**ST. TAMMANY PARISH SCHOOL BOARD
COVINGTON, LOUISIANA**

ADDENDUM 2

**BID #1898 – RENT/LEASE OF MODULAR
BUILDINGS FOR ABITA SPRINGS ELEMENTARY
October 6, 2026**

Questions and Corresponding Answers

1 ELECTRICAL RISER DIAGRAM - MODULAR BLDG

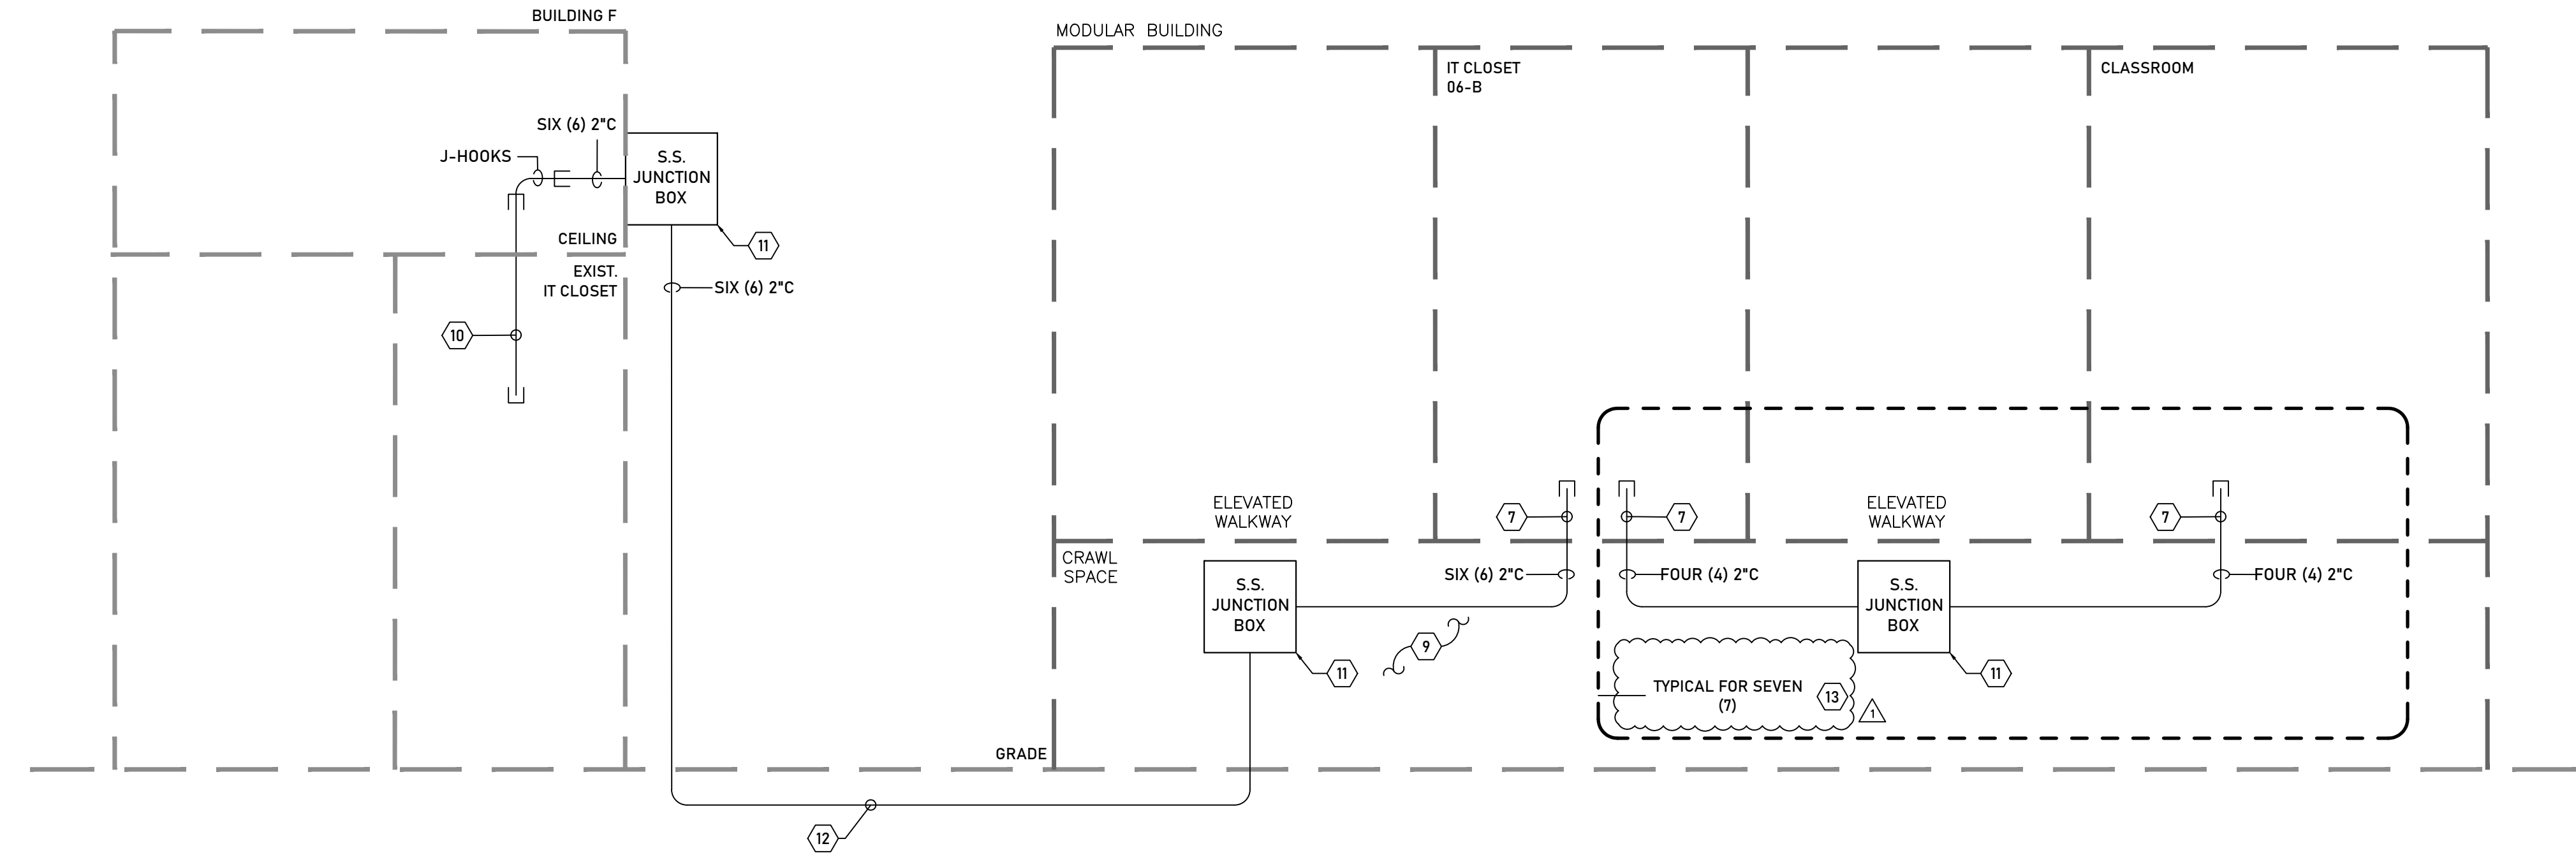
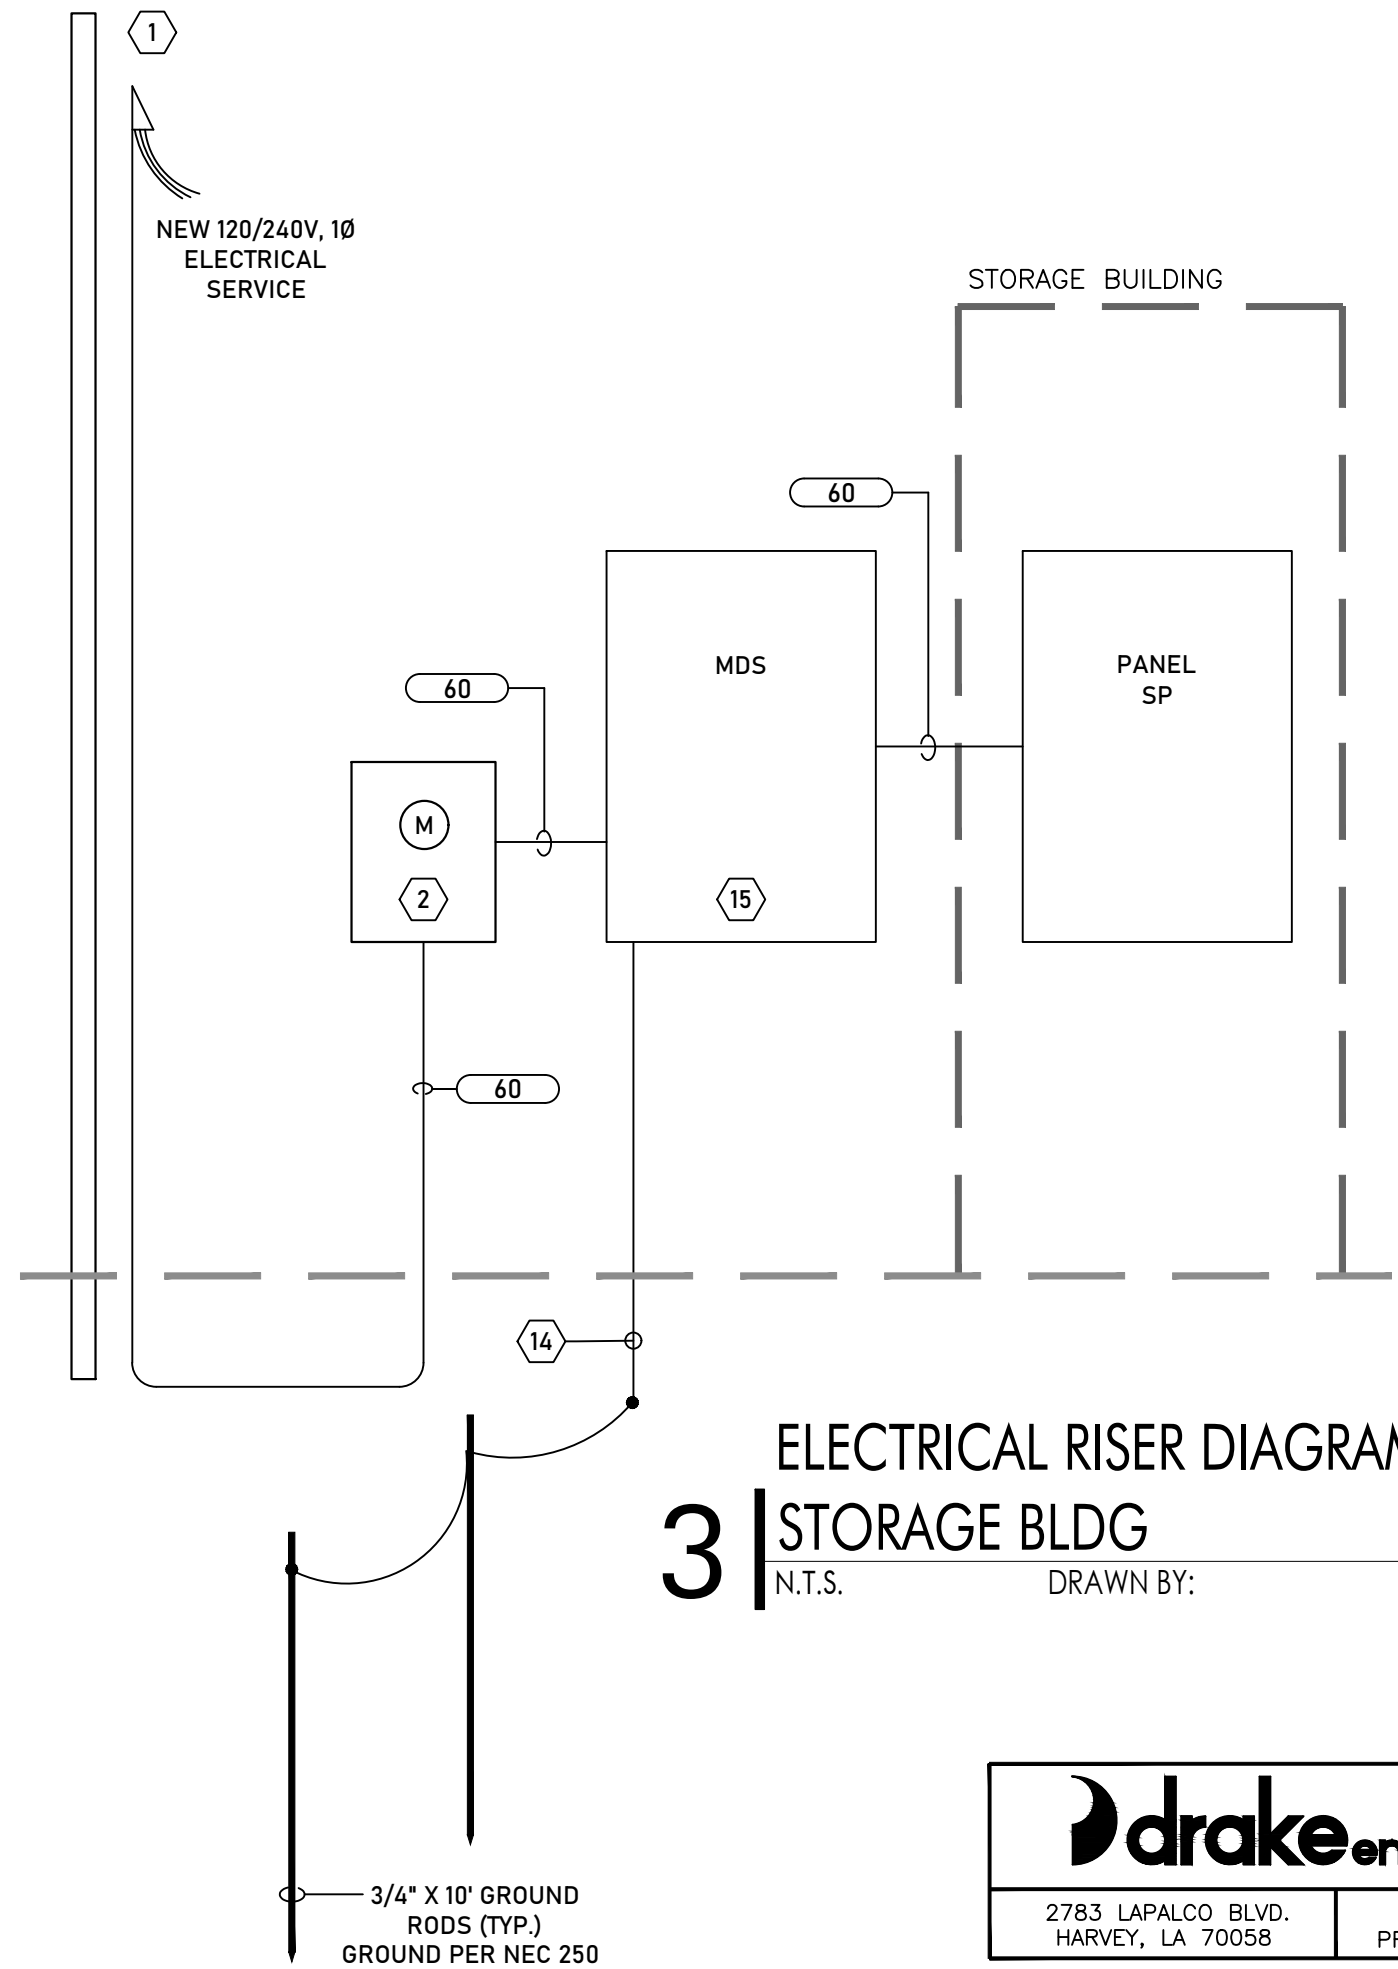
17	Building Systems	Electrical Panel Configuration – Spec vs. Drawings	Spec 2.2.k.viii; E1.01; E3.00 KN1; E4.00; E4.01	<p>Spec 2.2.k.viii calls for (4) 100A–200A, 10KAIC, 1-phase panels. E1.01/E4.00/E4.01 show ten 100A, 120/208V, 3-phase, 4-wire panels (8 classroom, 1 office, 1 restroom) fed from a 600A MDP (22kAIC) by others. Please confirm which governs. If drawings govern, confirm: (a) 3-phase panels; (b) minimum AIC rating / available fault current at modular panels; (c) panel locations (E3.00 KN1 "dedicated panel in room"); (d) 208V single-phase HVAC units acceptable; (e) feeder entry/penetration locations coordinated with the Infrastructure Contractor (E4.00 Note 7).</p> <p>A17. Bid the electrical panel configuration per drawings as baseline scope. Exact manufacturer construction is unknown prior to shop drawing submittals, making drawing layouts conceptual. The selected Modular Manufacturer shall determine final panel quantities and locations. Any scope variance from baseline drawings will be reconciled during submittal review. See attached updated electrical drawings.</p>
